PUBLIC HEARING MEMORANDUM

SUBJECT: **Working Session Memo for Petition #257-24** for SPECIAL PERMIT/SITE PLAN APPROVAL to amend Special Permit #176-19 to allow for changes to the approved site plan and for additional relief to allow a garage exceeding 700 square feet, to exceed FAR and a retaining wall exceeding four feet in height.

MEMORANDUM

Re: Special Permit – 1188 Chestnut Street

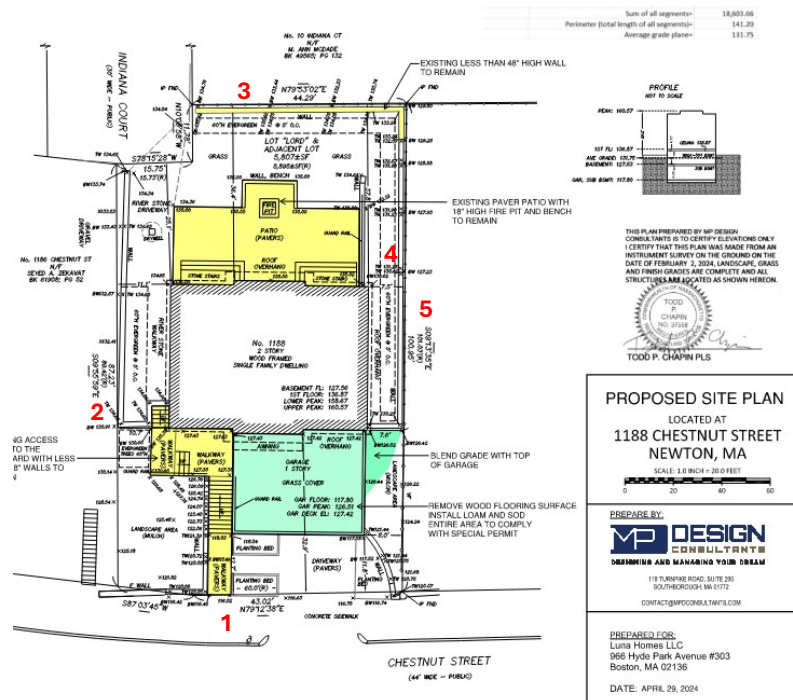
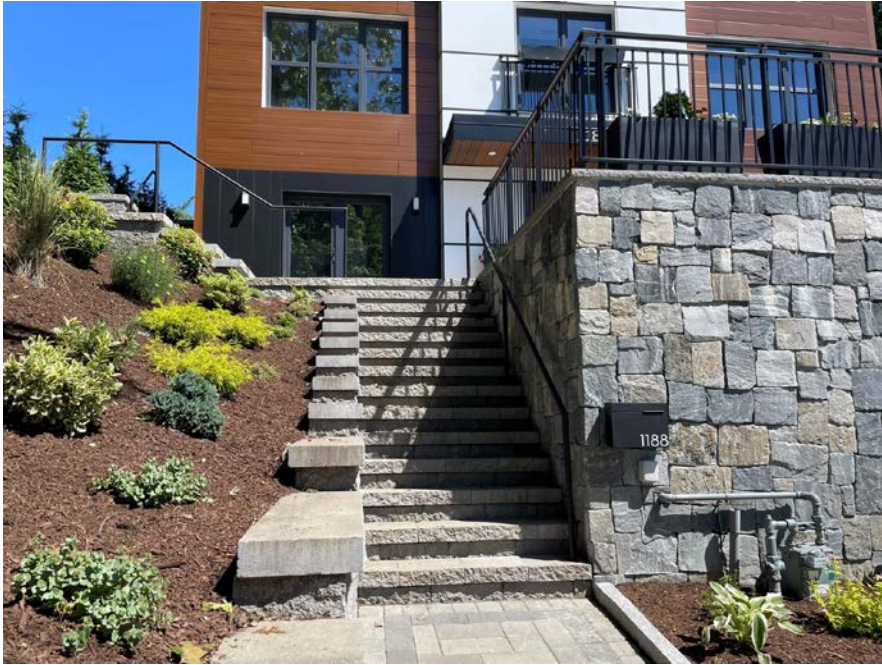
Walls over four (4) feet require a safety fence along its alignment. The applicant's engineer or design team needs to submit a written & stamped affidavit to Inspectional Services Department

~ ISD by a Professional Engineer certifying that the walls over four feet in height were designed and constructed in accordance with the manufacturers design requirements and specifications.

Walls over four feet are “structures” and require a Building Permit from ISD; the Engineering Division does not have jurisdiction on these walls or on retaining wall construction.

As Built Site Plan

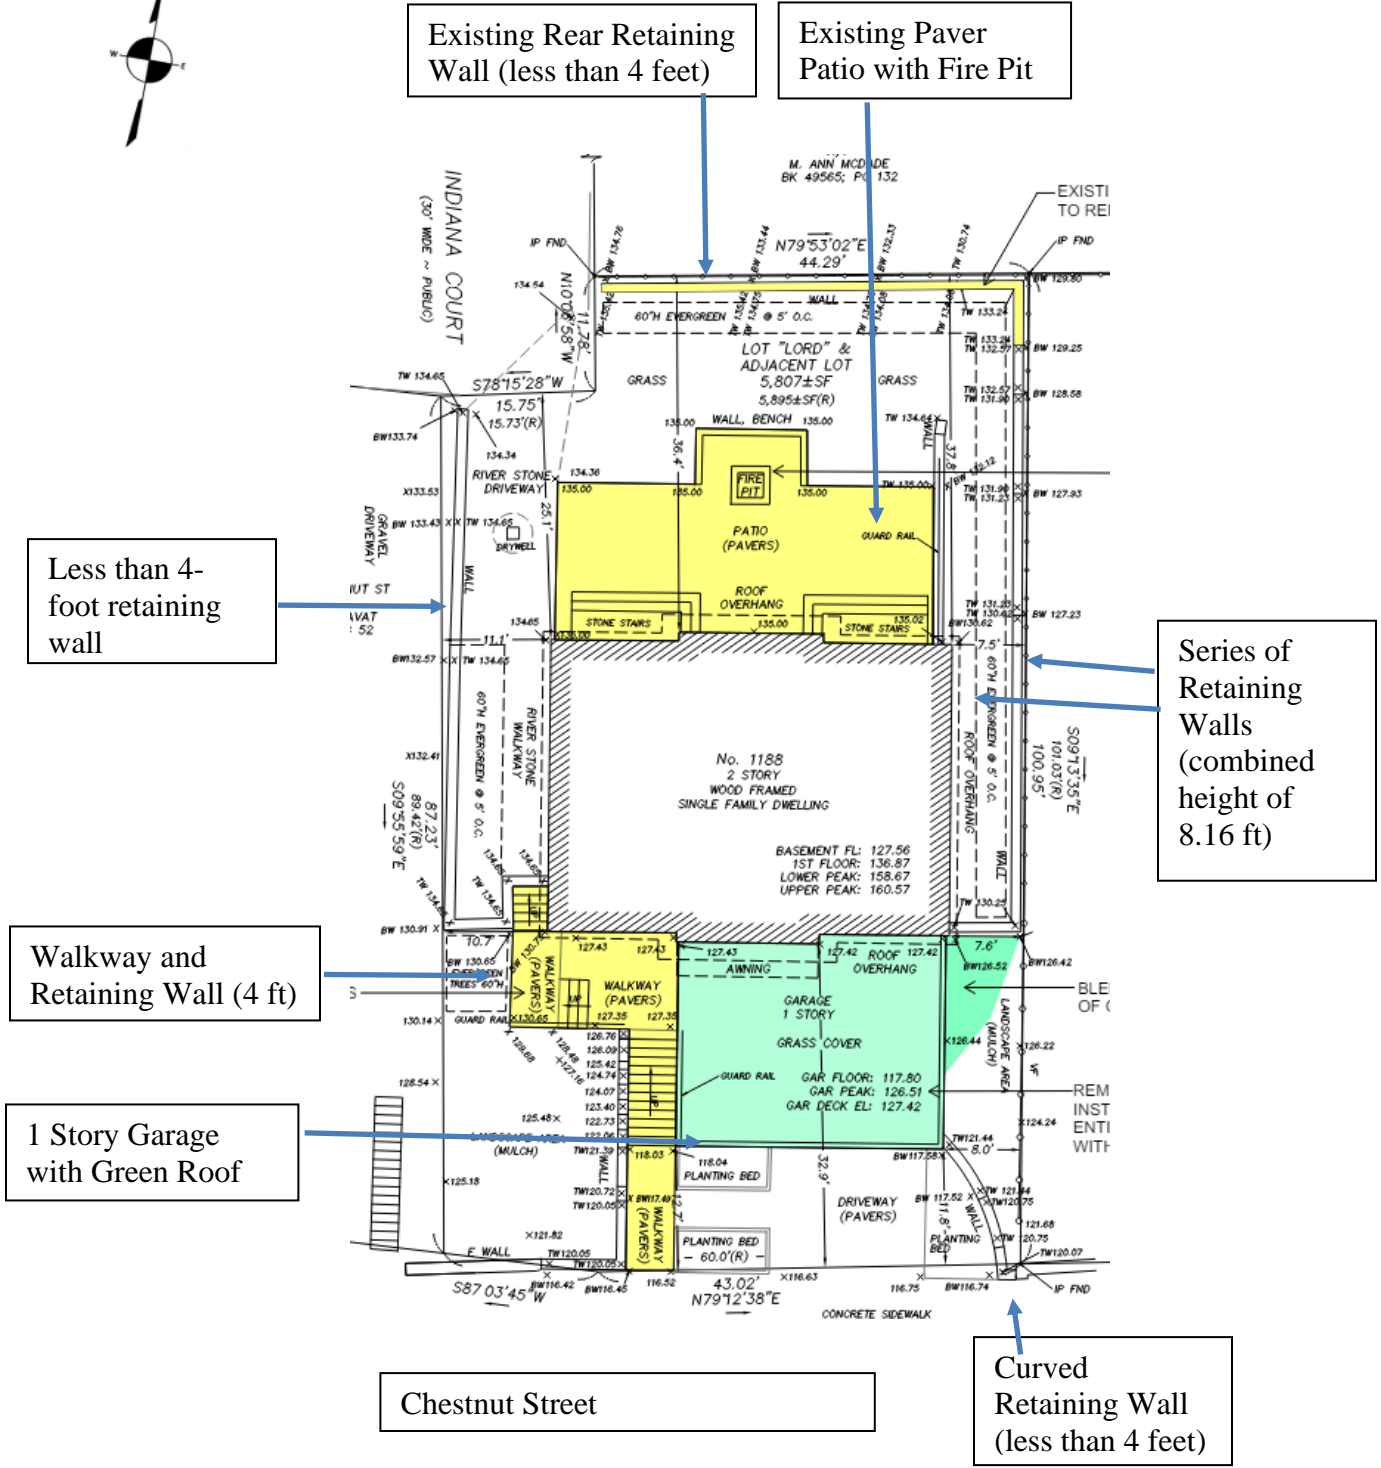
In addition to the changes to the project plans that require additional or different relief, the petitioners also made numerous changes to the project since the special permit plans that did not require additional relief. While these changes do not require zoning relief, they are summarized below to provide context to the overall changes related to the project and noted on the site plan.

- Increase in height from approved site plan with revised roofline from 26.1 feet to 29.2 feet
- Minor changes in the approved site plan setbacks from the project resulting in slight

- Retaining wall on rear lot line (noted as existing but not included on prior approved plans)
- Patio in rear of property now included instead of a deck included originally
- A retaining wall at the front eastern (right) corner of the lot was constructed in a curved rather at a right angle shown in the approved site plan
- A retaining wall constructed directly along the western (left) side lot line angled slightly into the property from south to north

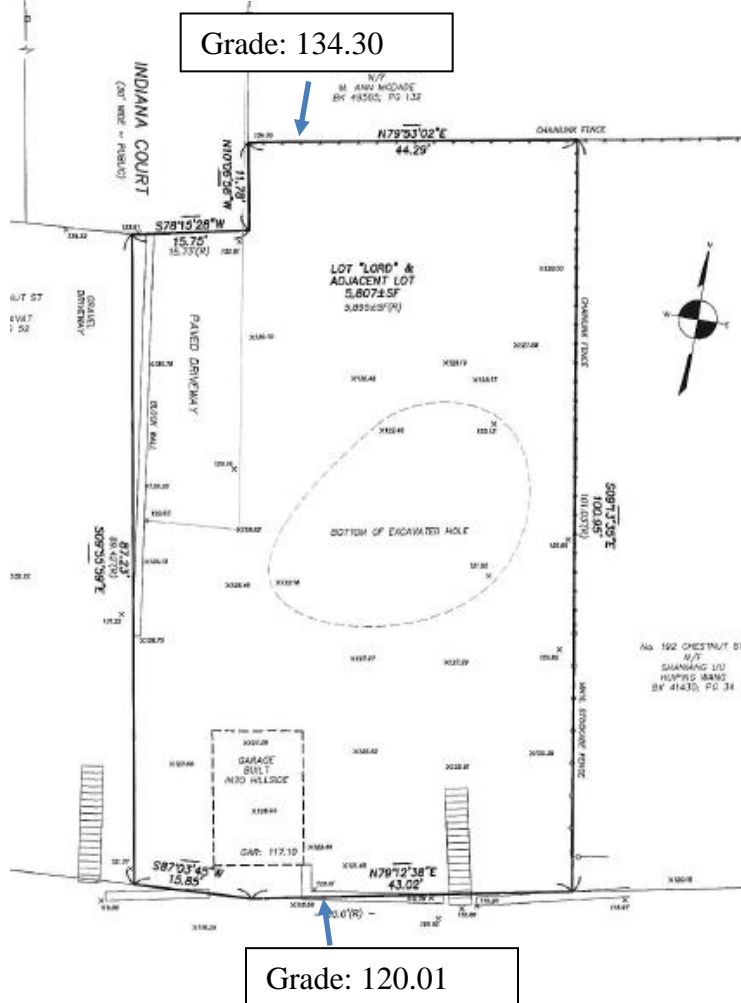
In the Planning Memo dated June 14, 2019 for the original special permit request, Planning did not support the enlarged garage from Chestnut Street because of the short setback from Chestnut Street, which could create safety issues due to limited visibility. Planning suggested the parking be located on Indiana Court. Staff also noted overgrown shrubbery on abutting properties that might hinder visibility. The petitioners have noted that they will be working with the neighbor to trim hedges on their property.

The site plan was approved by City Council in 2019 with the garage on Chestnut Street with relief for the garage to be located within the front yard setback, extending the prior nonconformity. As the constructed garage has only a subterranean connection to the main dwelling, it is treated as a detached structure. The original special permit-approved plans allowed for a two-car garage with two garage doors of approximately 600 square feet. The plans have been revised since and approved by a consistency ruling to include a 908-square-foot garage due to the removal of doors to expand the space to allow for three cars. The issue here is for the City Council to decide whether to approve the relief for the expanded garage over 700 square feet, which was not previously requested or approved.
